Palo Verde Nuclear  
Generating Station

**Subject: Palo Verde Nuclear Generating Station (PVNGS)  
Units 1, 2 and 3  
Docket Nos. STN 50-528, 50-529, and 50-530  
Response to NRC Request for Additional Information Regarding  
PVNGS Units 2 and 3 Steam Generator Tube Inspections**

**ARIZONA PUBLIC SERVICE COMPANY  
RESPONSE TO NRC REQUEST FOR ADDITIONAL INFORMATION  
REGARDING PVNGS UNITS 2 AND 3 STEAM GENERATOR TUBE  
INSPECTIONS**

Figure 1  
MRPC Graphic "Abnormal" Dent

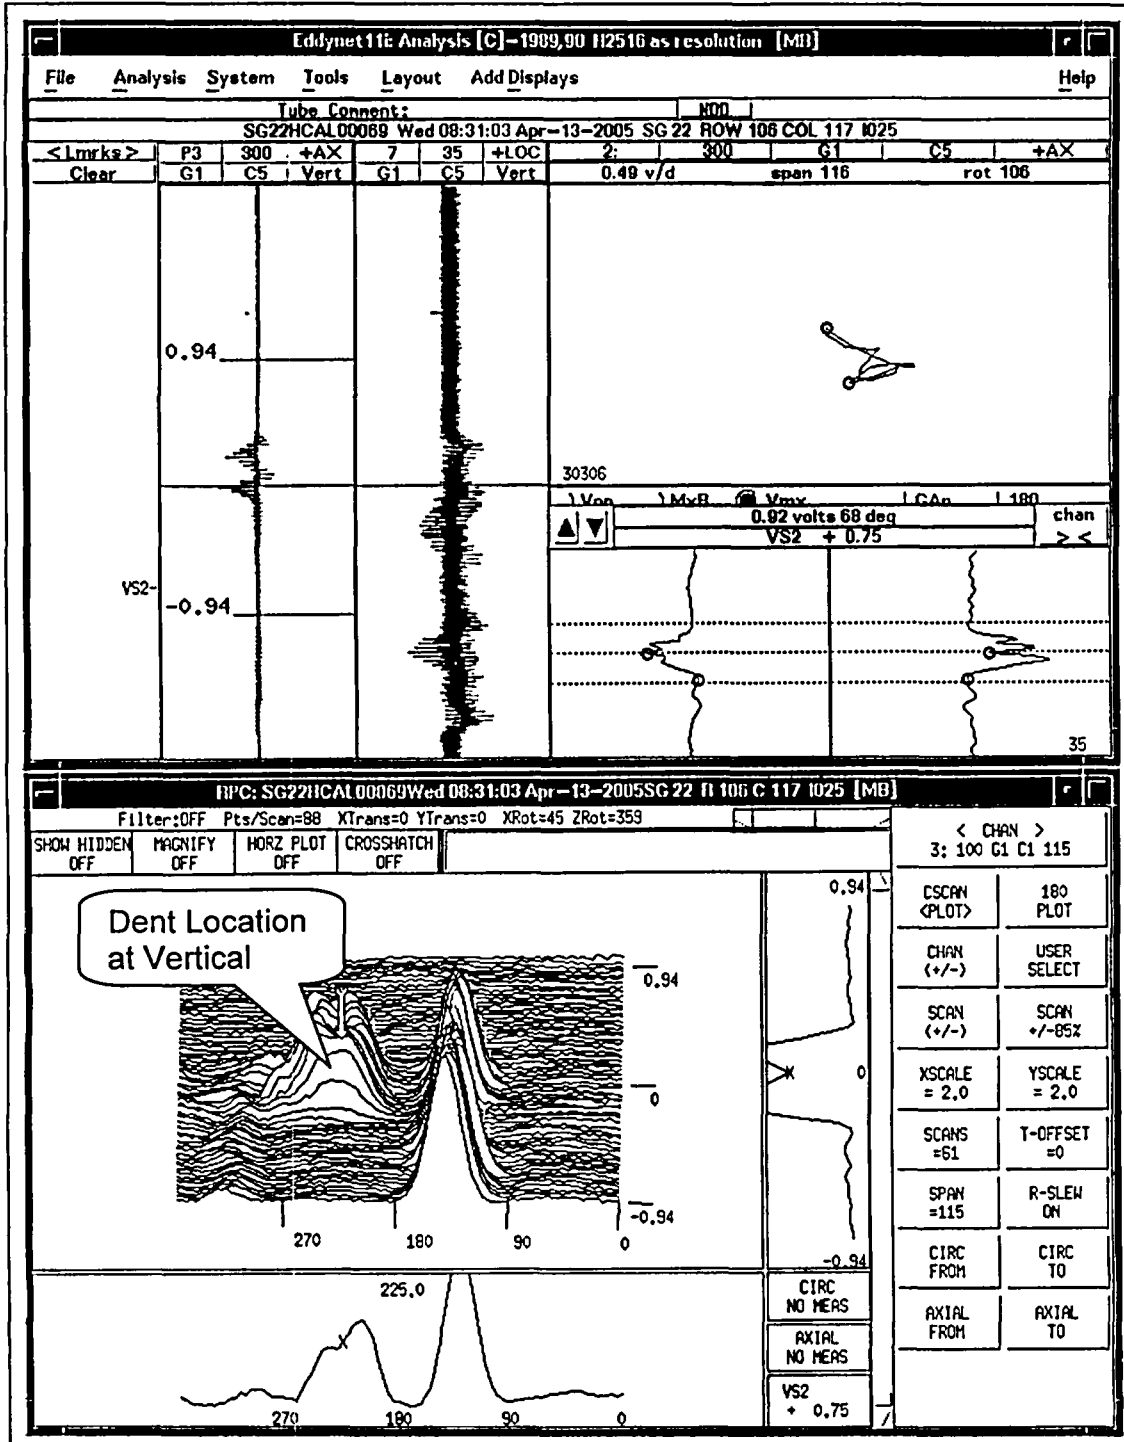
In Section 4.0 of your October 24, 2005 letter, you indicated that for steam generators 21 and 22, tubes were detected with abnormal dent indications. Were these indications present since the pre-service inspection? If so, please discuss whether they have changed since the pre-service inspection and the reasons for any change. If they were not present in the pre-service inspection, please discuss the cause of the dents. Please discuss whether these dents are considered "abnormal" since they are similar to the dent indication that was the cause of your 2004 primary-to-secondary leak.

All of the dent indications listed in Section 4.0 of the October 24, 2005 letter were present during the pre-service examinations (PSE). No changes were noted in any of the dent rotating coil examinations. The source of these abnormal dents was most likely the product of the initial steam generator assembly. All four abnormal dent indications (three in SG 21 and one in SG 22) appear to be directly associated with a vertical strap support bar. Note the NDE graphic in attached Figure 1 which indicates that the location of the rotating coil dent indication is at the vertical strap (VS2).

These dents were considered "abnormal" by APS because they exhibited vertical amplitudes higher than typical dent indications. This condition/classification is one of the lessons learned during the 2004 midcycle (leaker) outage and subsequent dent evaluations. The PVNGS Analysts' Technique Sheet for the +Point examination of dents requires the analysts to record any dent with a vertical amplitude over 0.2 volts with the +Point 300 kHz channel. These are then reviewed by the APS Level III for location, appearance, and the potential for masking of other types of flaw indications.

The abnormal dent indications were similar to the dent indication in SG 21 Row 156 Column 143 that leaked during Cycle 12 in that they had higher vertical voltage than other typical dent indications. Using the +Point 300 kHz channel, the vertical amplitude of the leaking tube was 0.94 volts compared to voltages of 0.29, 0.30, 0.67 and 0.92 for the tubes listed in Section 4.0. As indicated above, the four tubes in U2R12 were associated with a support bar, whereas the dent in the leaking tube was not directly associated with a support bar and the dent in the leaking tube was attributed to damage caused by a packing crate screw.

Although it is unlikely that these dents were caused by crate screw damage, APS took the conservative action and removed the affected tubes from service by plugging.

**Figure 2**  
**Set Screw Installation Unit 1 and 2 RSg**

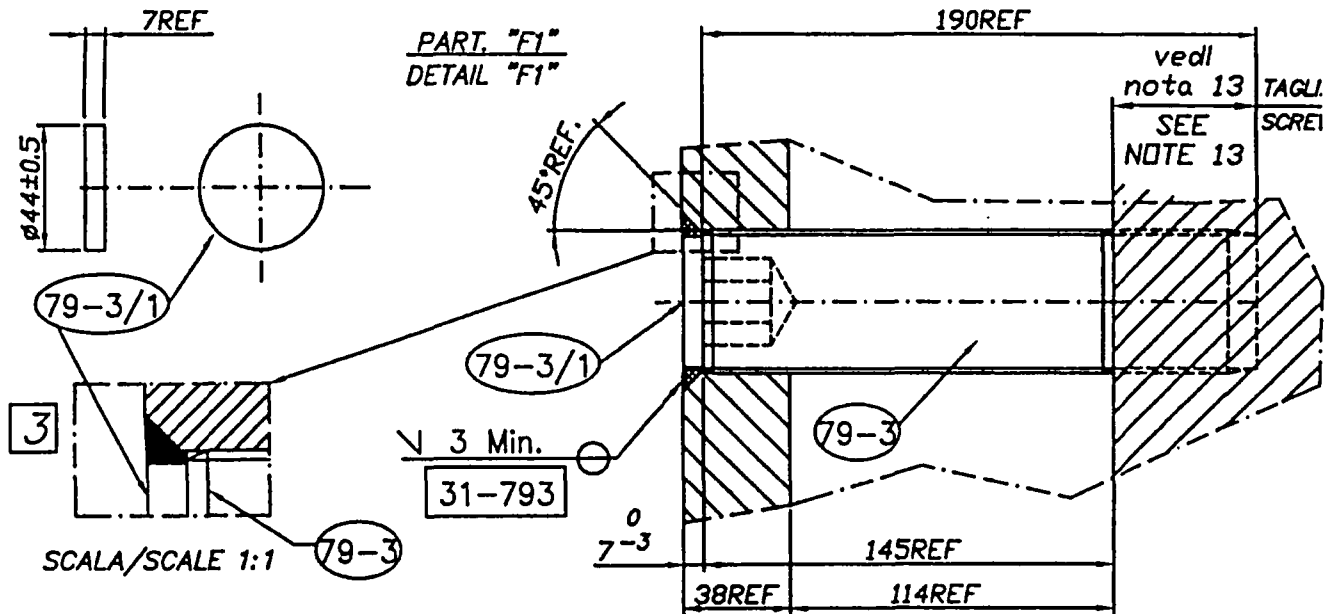
It is the NRC staff's understanding that the Palo Verde, Unit 2, replacement steam generators have an economizer with a similar set screw configuration as that in Unit 3 (which experienced degradation). As a result, please discuss whether any inspections were performed to confirm the integrity of these locations. In addition, please discuss whether any other secondary side inspections were performed during the outage.

The main design differences between the original steam generators (OSGs) and RSGs with respect to the feedwater box include; the set screw length exposed to feedwater flow, the gap setting against the shell and the set screw installation technique. The difference in set screw material (SAE Gr.5 vs. SA-193 Gr. B7) was not judged to be a significant difference.

The increased set screw length exposed to feedwater flow was evaluated with respect to the possible negative effect of increased flow forces on the set screw. The increased force on the set screw was calculated to negligibly increase by approximately 3% in the RSGs. Alternatively, the increased length permitted setting the gap between the set screw and the shell at 0.06 inches in the RSGs vs. 0.25 inches in the OSGs. This was evaluated to have a positive effect during accident

conditions. Although not likely to help limit the erosion or wear of the feedwater box at the set screw location, if erosion does occur, the combination of the smaller gap and the seal plate on tube side of the feedwater box would limit the movement of the set screw. As a result, it is less likely that the same amount of erosion as seen in the Unit 3 OSGs would lead to a set screw failure.

The most significant difference between the OSGs and the Unit 1 and 2 RSGs is the installation of a seal plate. In the OSGs the set screws were welded to the tube-side face of the feedwater box then ground flush. Because of the hardness of the set screw material, very little of the weld metal adhered to the set screw. As a result, there was a small leak path through the threads that allowed water to leak from the feedwater box to the economizer region of the steam generator. Conversely, the Units 1 and 2 RSGs have a 0.25-inch carbon steel plate that is groove-welded flush to the tube-side face of the feedwater box (see attached Figure 2). This seal plate is a significant design improvement in the RSGs. Although the primary purpose of the seal plate was to avoid welding to hardened bolting material, it has the secondary effect of eliminating the jetting flow through the set screw hole if the set screw falls out. While this change might not significantly affect the probability of a set screw failure in Units 1 and 2, it will have a significant effect on the consequences of a failure.
